Case File Number PLN15179-R01

Proposal: Revision of a proposal to construct a new 36-story building with

DESIGN REVIEW COMMISSION
SUBMITTAL PACKAGE

ELEVATIONS SOUTH + EAST

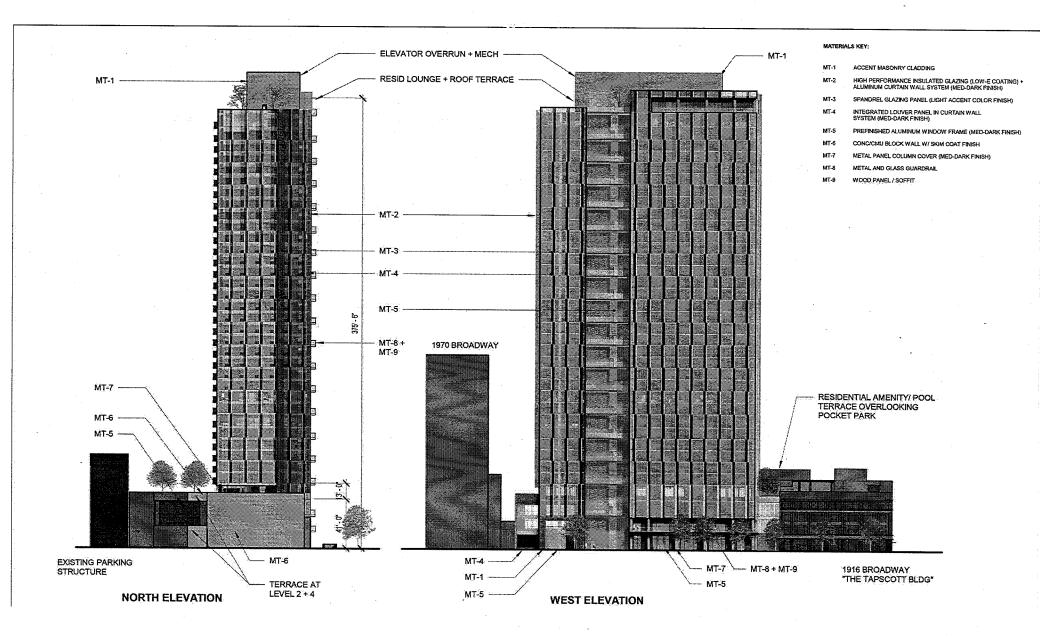
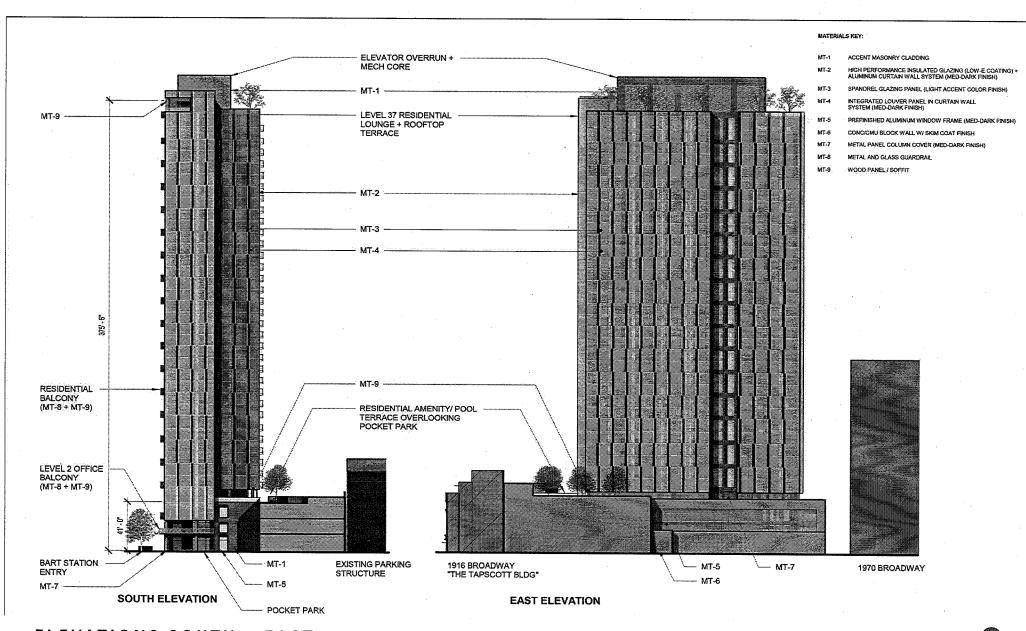
However, staff is concerned that the east elevation has not been given the same level of design attention as the west elevation. The east elevation, which will be highly visible from the Lake Merritt area and beyond, does not have a roof element to define the top of the building, and the recess separating the volumes on the façade contains windows instead of a more visually interesting element, such as the zipper in the front facade.
